Notice of Intent

Sundry ID: 2659296

BLM FLUID MINERALS P&A Geologic Report

**Turner Hughes 8
San Juan, NM**

Proposed P&A

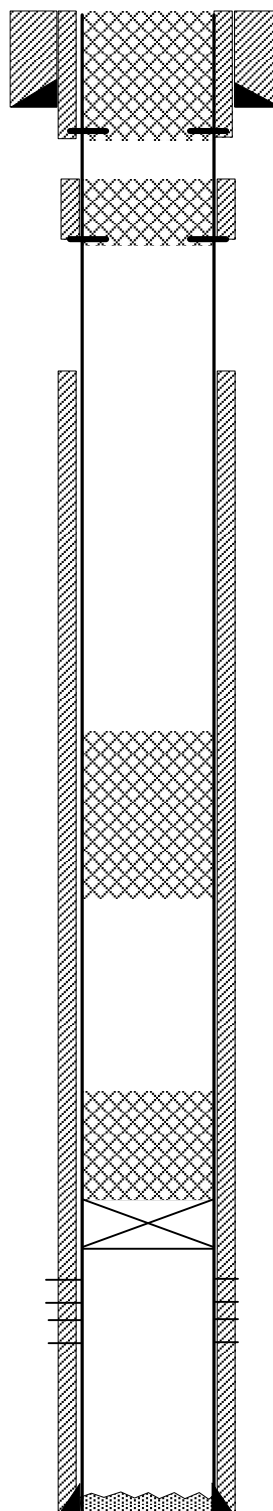
- BLM pick for the top of the Nacimiento formation top varies from Operator submission.

- Bring the bottom of Plug #2 down to 1697' to cover the Kirtland formation top.

1. Plugging operations authorized are subject to the attached "General Requirements for Permanent Abandonment of Wells on Federal and Indian Lease."
2. Farmington Office is to be notified at least 24 hours before the plugging operations commence at (505) 564-7750.
3. The following modifications to your plugging program are to be made:
 - a) Bring the bottom of Plug 2 down to cover a minimum of 1697' to cover the Kirtland formation top.

PLUG 2
32 sx cement 1,433' - 1,697'
